SERVICE PROCEDURE

22527
FEBRUARY, 2023

SUBJECT: SAFETY RECALL

Transverse Torque Rod Fasteners on certain 2022 and 2023 IC Bus® CE school bus models and 2022 IC Bus® RE and Electric CE school bus models built 02/01/2022 thru 11/15/2022 with feature code 14TBH, 14TBS, or 14TBT (Suspension, rear, air single; International IROS)

Figure 1. Transverse Torque Rod Axle

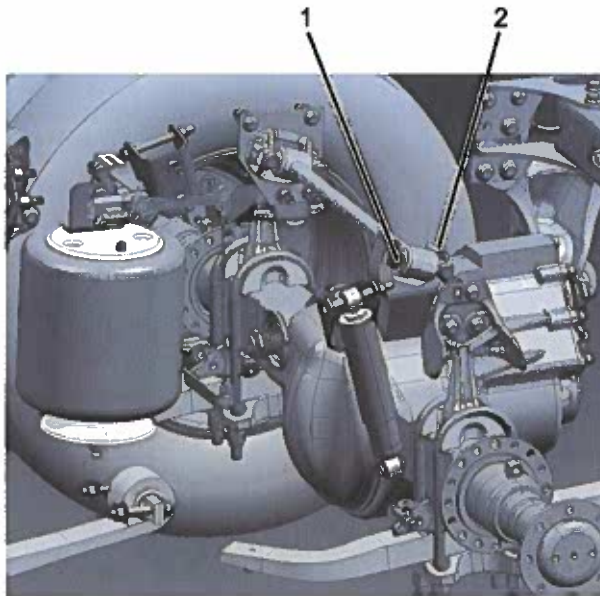
The fasteners of the transverse torque arm to the rear axle housing may not have been tightened to their specified value at time of assembly. Over time, they may become loose or separate, resulting in the rear axle shifting from side to side. In a bus application, a rear axle that shifts from side to side can cause reduced handling performance and may result in an increased risk of injury if students must be transferred to another bus near the roadway.

1. Transverse torque rod axle side bolt (2)
 2. Transverse torque rod axle side nut (2, 1 not shown)
5. Remove bolts (Figure 1, Item 1) and nuts (Figure 1, Item 2) that fasten transverse torque rod to axle. Discard bolts and nuts.
 6. Install new bolts (Figure 1, Item 1) and nuts (Figure 1, Item 2) that secure transverse torque rod to axle.
 7. Tighten nuts to 217-239 lb-ft (294-325 N•m).
 8. Remove wheel chocks.
